# Rezoning Application:

## MM 22-0313

Development Services Department

## AGENCY REVIEW COMMENT SHEET

### 2.3 Proposed Site Plan (partial provided below for size and orientation purposes. See Section 8.0 for full site plan)

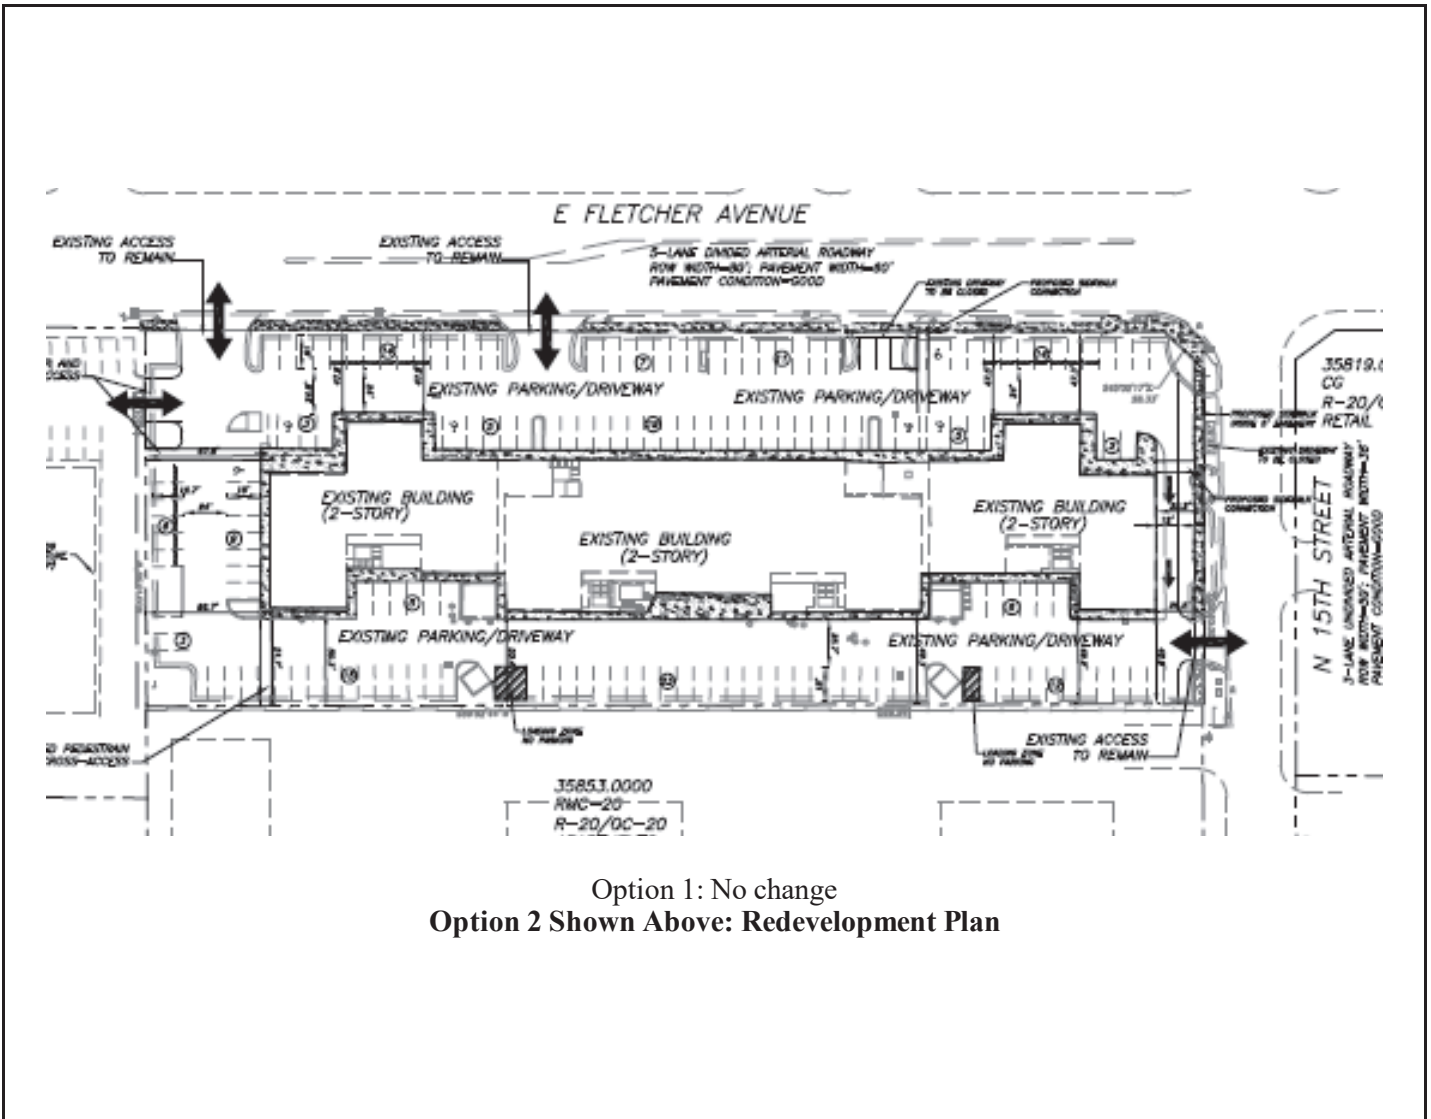
There are existing parking spaces which appear to encroach in the County's N. 15<sup>th</sup> St. right-of-way. Under Development Option 2, the developer will be required to remove those spaces and construct a sidewalk along the project frontage, which will require placement of the sidewalk within the site and conveyance of an easement for public access and maintenance proposes to the County. The developer may be required to remove such spaces under Option 1 in the future, at the request of Hillsborough County, if such spaces were not properly permitted.

As shown on the development Option 2 site plan, the developer is proposing to modify the site to remove the easternmost access on Fletcher Ave. and the northernmost access on N. 15<sup>th</sup> St. The applicant is also proposing to construct a pedestrian cross access stubout along its southern project boundary as well as a vehicular/pedestrian cross access connection/stubout along its western project boundary. While the site would still not meet all applicable standards, these changes will drastically improve compliance with applicable LDC standards and improve the safety of access to the site, while still providing for adequate vehicular and pedestrian access given the constraints created by the existing parcel configuration and existing building within the site, which the developer is proposing to retain.

The applicant provided parking calculation on the Option 2 site plan. As shown, the shopping center use requires 152 parking spaces, and the commercial apartment uses require 56 parking spaces. Pursuant to Sec. 6.11.16.B. of the LDC. "Off-street parking requirements shall be separately calculated for the non-residential component and the residential component of the building, and the greater number of required parking spaces shall be provided.". As such, the project is required to construct 152 parking spaces, and they are proposing 159 spaces for Option 2.

- 2.2 In the event the developer desires to construct commercial apartments or alters the existing structure or grounds such that the site must come in through the plat/site/construction plan review processes, then the developer shall modify the parking area areas and site access connections to comply with current LDC, Transportation Technical Manual, and other applicable standards. This scenario is depicted on the Option 2 GDP.

- 3.2.5 Modify the existing parking facility to add/remove new parking spaces as shown on the GDP, in order to reach the minimum number of spaces required pursuant to Section 6.05 of the LDC as well as ensure drive aisles meet minimum width requirements pursuant to the LDC/Transportation Technical Manual;

- 3.2.6 Restripe parking areas as necessary to provide dumpster area buffers/ loading zones as shown on the GDP; and,
    - 3.2.7 Construct minimum 5-foot wide internal and external sidewalks and crosswalks as generally shown on the GDP. With respect to the sidewalk to be constructed within the

13.5' throat depth

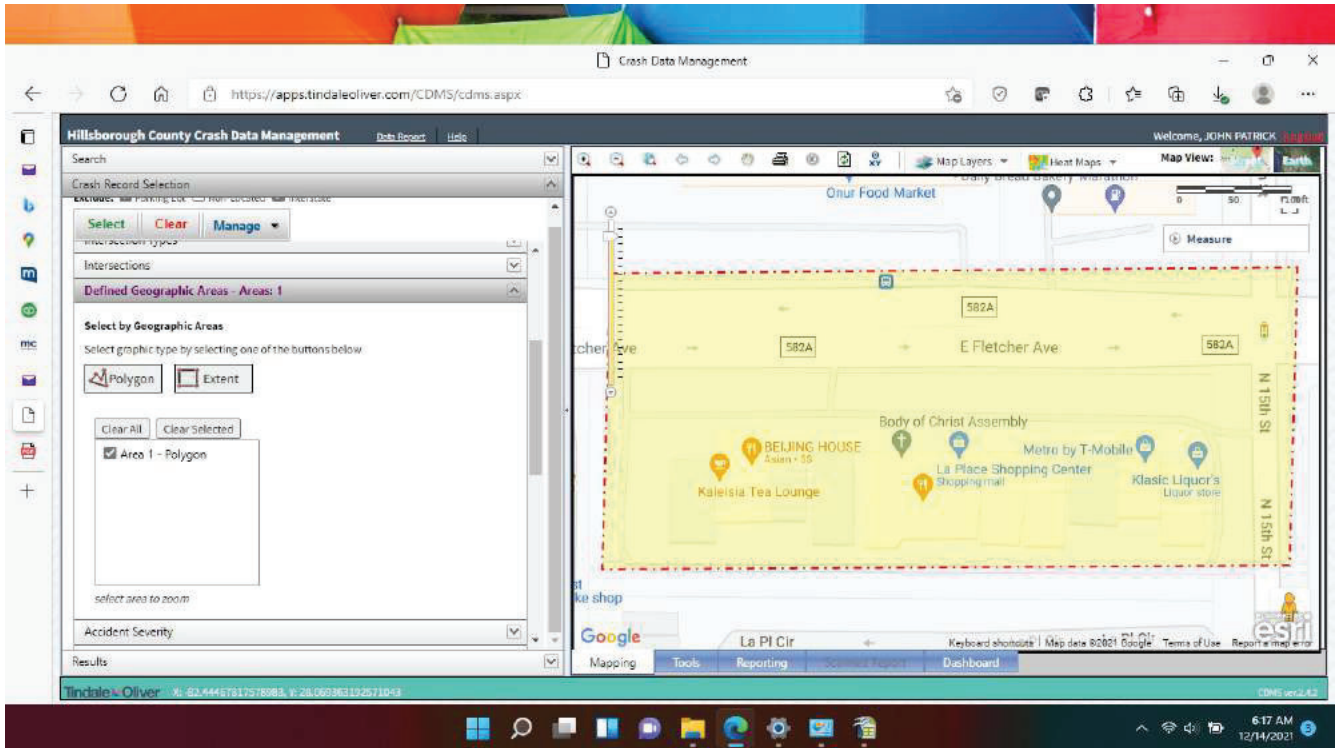
The subject property is in for review, as is shown on the attached **Site Plan** and **Location Map**. This variance is to request that the developer not be required to meet the above-described throat depth measurement at one of the two project driveways. See **Throat Depth Exhibit**.

70 foot ROW

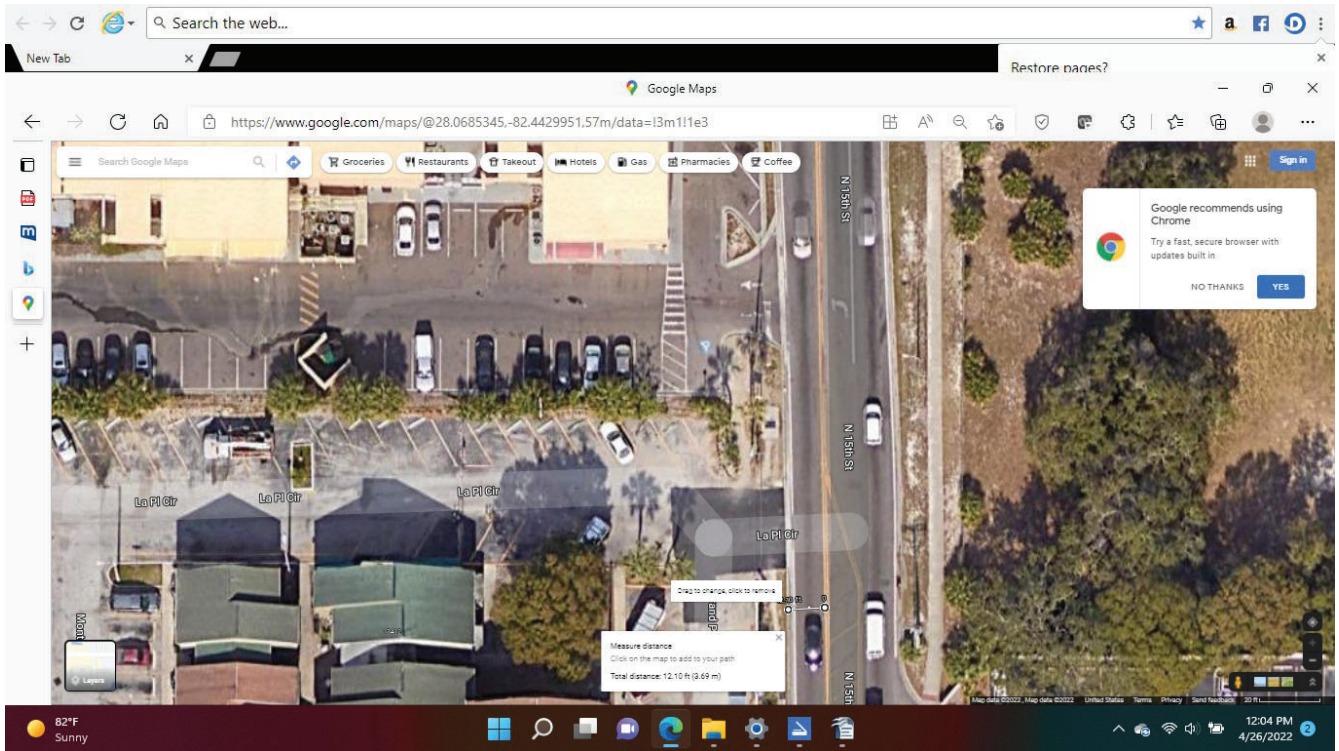
The subject property is in for review as is shown on the attached **Site Plan and Location Map**. This variance is to request that the developer not be required to bring 15<sup>th</sup> Street up to TS-3 standards.
